CYPRESS COVE SUBDIVISION

APPLICATION NUMBER 13 DATE October 4, 2007

DETAIL SITE PLAN

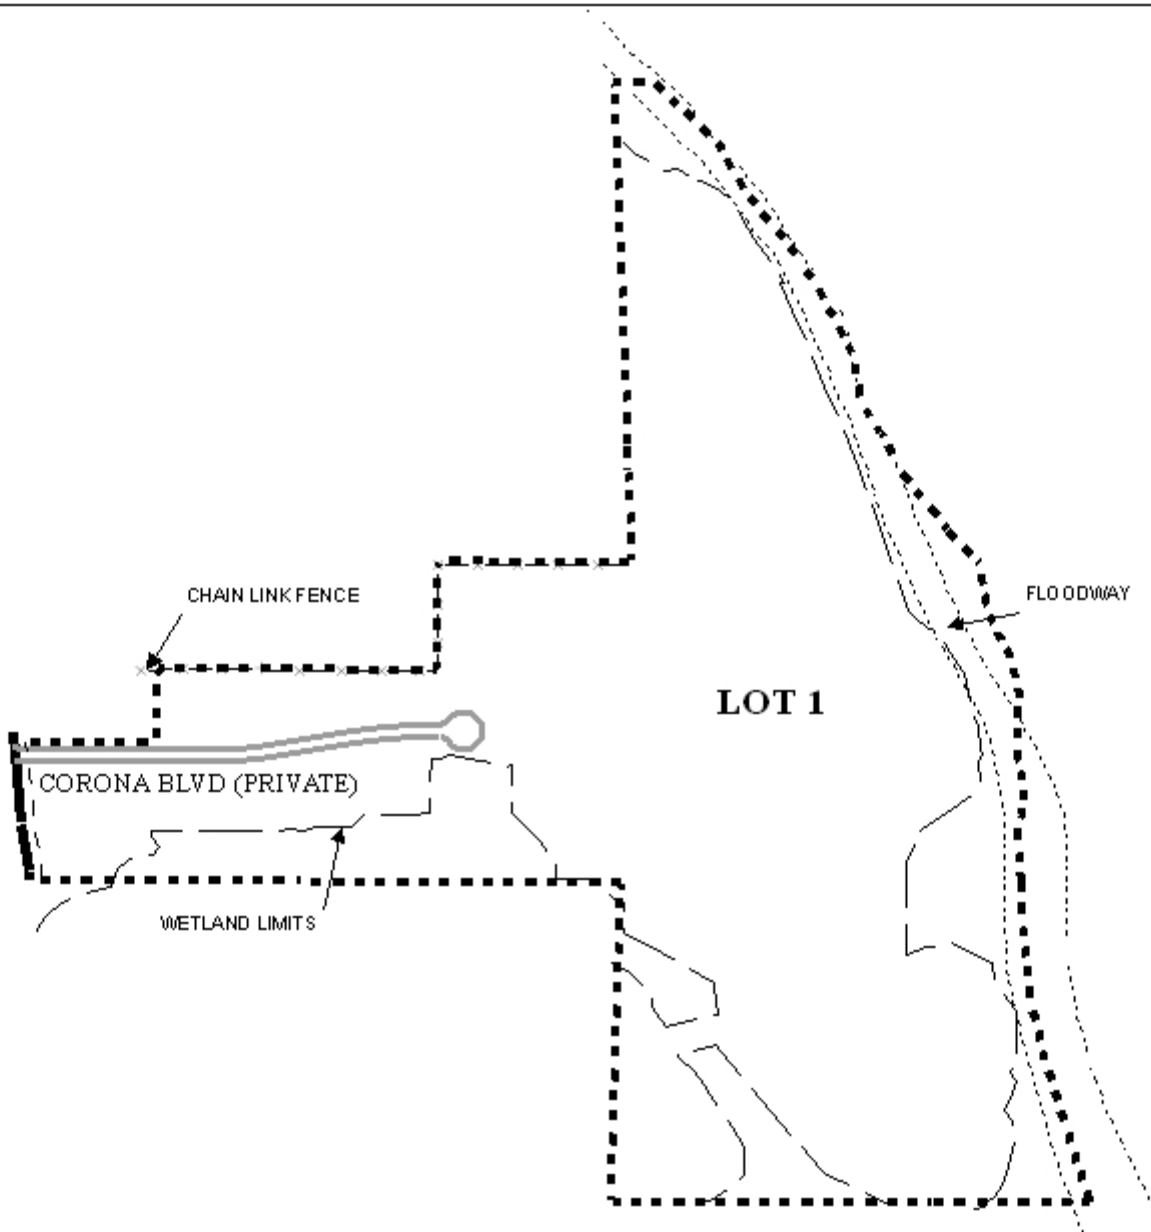
As mentioned above, the site consists of four metes-and-bounds parcels. However, it appears that the two Eastern-most parcels were created without the proper subdivision process to separate them from the remainder of their parent parcels extending further East. And, the Southeastern-most portion of the site does not include a portion of the tax parcel extending further South of the site. The remainder of all the parent parcels should also be included in this subdivision.

Schillinger Road, which has a variable right-of-way, is shown as a major street on the Major Street Plan, and as such requires a 100-foot right-of-way; therefore, the dedication of sufficient right of way to provide 50-feet from the centerline should be required, or the plat should be revised to indicate sufficient right-of-way currently exists. As proposed, the subdivision would have frontage along Schillinger Road and Adobe Ridge Road South. The plat depicts access to the site via an existing private street. As the site will probably be developed for commercial purposes, a note should be placed on the final plat limiting the site to the current curb cut to Schillinger Road South. A note should also be placed on the final plat stating that there shall be no access to Adobe Ridge Road South.

As indicated on the vicinity map and plat, the site contains a creek and significant areas of wetlands, and as such the area may be considered environmentally sensitive; therefore, the approval of any necessary federal, state, and local agencies would be required, and a note stating such should be placed on the final plat.

The required 25' minimum building setback line is shown on the plat but not identified as such; therefore the minimum building setback line should be shown and indicated along Schillinger Road South and all Western boundaries of the site. The plat was labeled with the area in acres and this should also be included on the final plat or a table depicting the same information should be provided.

- 1) the inclusion of the remainder of the two parent parcels to the East in this subdivision;
- 2) dedication of sufficient right-of-way to provide 50' from the centerline of Schillinger Road South, or the revision of the plat to indicate sufficient current right-of-way;

- 3) placement of a note on the final plat stating that the site is limited to the current private street curb cut to Schillinger Road South;
- 4) placement of a note on the final plat stating that access to Adobe Ridge Road South is denied;

- 5) placement of a note on the final plat stating that the approval of all applicable federal, state and local agencies is required prior to the issuance of any permits or land disturbance activities;

- 8) depiction and labeling of the 25' minimum building setback line along Schillinger Road South and all Western boundaries of the site; and
- 9) labeling of the lot with its area in acres or the provision of a table on the plat depicting the same information.
